## TECHNICAL ORDER NO. 63-45 ORDERS CONSOLE AND JACK BOX TYPE CONTROLS MODIFIED

**Modifications of C-127/ARC, C-126/ARC, C-137/ARC Console Type Controls, C-38/ARC-5 Control Box Type Control Will Result in Better Operation of Aircraft Radio Systems**

BuAer Technical Order No. 63-45, dated 12 July 1945, outlines modifications which will improve operations of the radio communications-radio navigation system in VF, VTB and VSB aircraft by presenting a more equalized audio output level to the pilot. Further, these changes will reduce the interaction between the audio output levels of the communication and navigation receivers.

Figure 1—Modification of C-127/ARC Master Console Unit

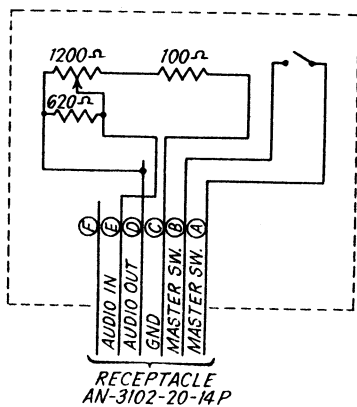
1. Disconnect wires which are presently connected to pins "D" and "E" of receptacle AN-3102-20-14P.
2. Connect wire which was formerly on pin "D" to pin "E."
3. Connect wire which was formerly on pin "E" to pin "D."
4. The wiring in this unit should now be in accordance with BuAer drawing E-1270 (Fig. 1).

Figure 2—Modification of C-126/ARC Mixing Console Unit

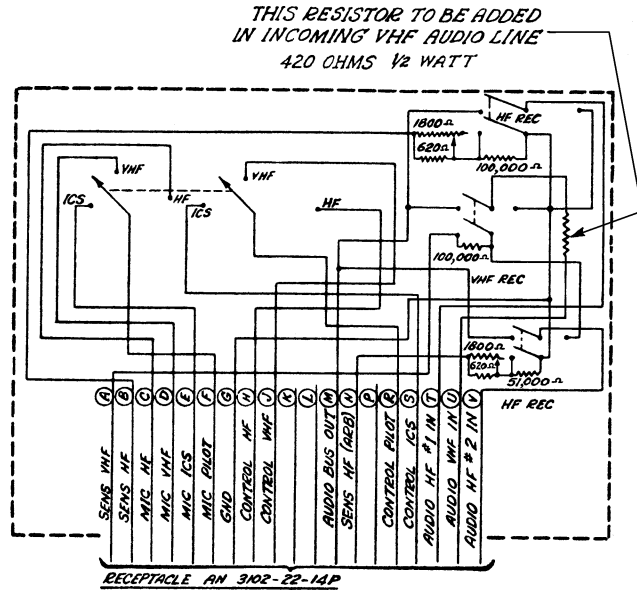
1. Procure a 400 to 450-ohm  $\frac{1}{2}$ -watt fixed resistor (ASO Stock No. R16-R-17263-53 is suitable) for insertion in the incoming VHF audio line.
2. Disconnect from center pole of VHF audio "OFF-ON" toggle switch the lead which runs from this switch to pin "U" of receptacle AN-3102-22-14P.

3. Connect one end of the above resistor to this lead.
4. Connect the other end of the resistor to the vacated center pole of the VHF audio "OFF-ON" toggle switch.
5. The wiring in this unit should now be in accordance with BuAer drawing E-1268 (Fig. 2).

Figure 3—Modification of C-137/ARC Mixing Console Unit

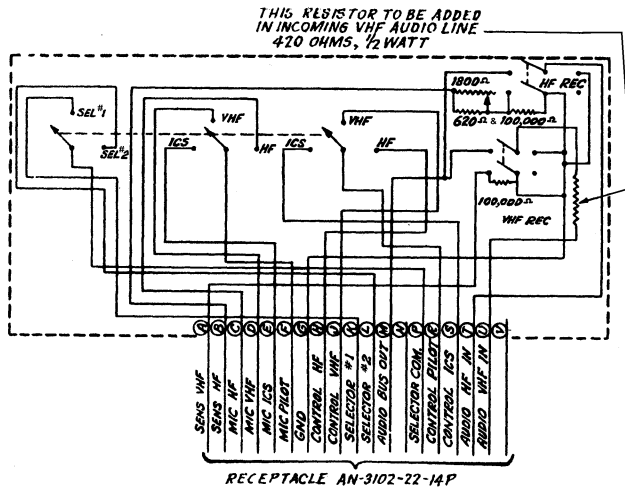
1. Procure a 400 to 450-ohm  $\frac{1}{2}$ -watt fixed resistor for insertion in the VHF incoming audio line.
2. Disconnect from center pole of VHF audio "OFF-ON" toggle switch the lead which runs from this switch to pin "U" of receptacle AN-3102-22-14P.
3. Connect one end of the above resistor to the vacated center pole of the VHF audio "OFF-ON" toggle switch.
4. Connect the other end of the resistor to the lead running to pin "U" of receptacle AN-3102-22-14P.
5. The wiring in this unit should now be in accordance with BuAer drawing E-1269 (Fig. 3).

Figure 4—Type C-38A/ARC-5 Main Control Unit

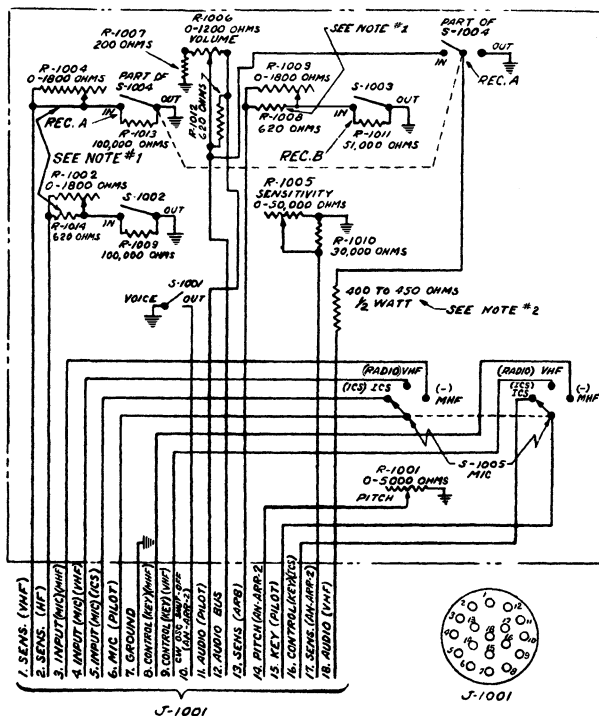
1. Disconnect lead from rotating arm of potentiometer R-1006.
2. Disconnect both leads from high side of the above potentiometer.
3. Connect lead that was formerly on the rotating arm to the high side of the potentiometer.

NOTES:  
 1. STARTING WITH SERIAL #4501 SHORT CIRCUIT ADDED ACROSS R-1004, RESISTOR 1014 ADDED, AND RESISTOR R-1008 CHANGED FROM 2000 TO 620 OHMS ON CBY UNITS ONLY. ALL CCT UNITS HAVE CHANGE SHOWN.  
 2. THIS FIXED RESISTOR TO BE ADDED IN INCOMING VHF AUDIO LINE.

4. Connect the two leads that were formerly on the high side to the rotating arm of the potentiometer.
5. Procure a 400 to 450-ohm 1/2-watt fixed resistor for insertion in the VHF incoming audio line.
6. Mount the above fixed resistor in a convenient place in the control unit.
7. Remove the lead running from pin "18" of receptacle J-1001 to the center pole of S-1004.
8. Run new lead from pin "18" of the above receptacle to one side of the fixed resistor.
9. Run new lead from the other side of the fixed resistor to the center pole of switch S-1004 which was vacated by the removal of the old lead.
10. The wiring in this unit should now be in accordance with BuAer drawing E-1253 (Fig. 4).

Figure 5—Modification of J-22B/ARC-5 Jack Box

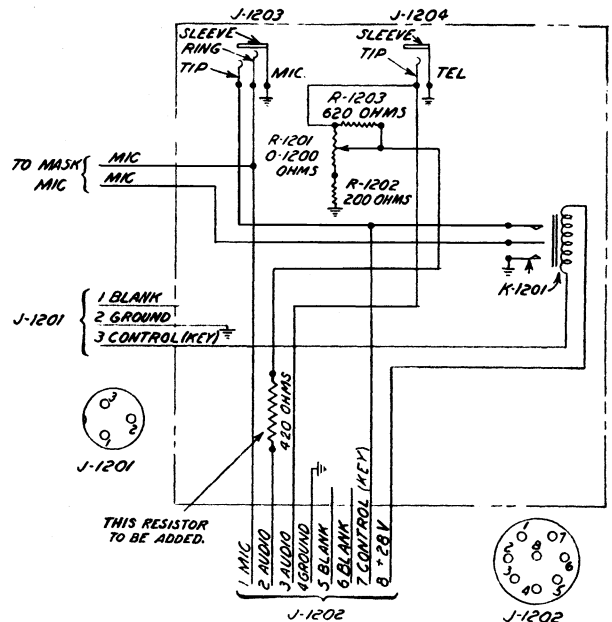
1. Disconnect from high side of potentiometer R-1201 the lead which runs to pin "2" of receptacle J-1202.
2. Disconnect lead from rotating arm of the above potentiometer which runs from the potentiometer to phone jack J-1204.
3. Connect lead that was formerly on the high side of the potentiometer to the rotating arm of the potentiometer.
4. Connect the lead that was formerly on the rotating arm of the potentiometer to the high side of the potentiometer.

5. Procure a 400 to 450-ohm  $\frac{1}{2}$ -watt fixed resistor for insertion in the incoming audio line from pin "2" of receptacle J-1202.

6. Mount the above resistor in a convenient place in the box.

7. Remove the lead from pin "2" of receptacle J-1202.

8. Run new lead from pin "2" of the above receptacle to one side of the resistor.

9. Run lead from the other side of the resistor to the rotating arm of the potentiometer R-1201.

10. The wiring in this unit should now be in accordance with BuAer drawing E-1276 (Fig. 5).
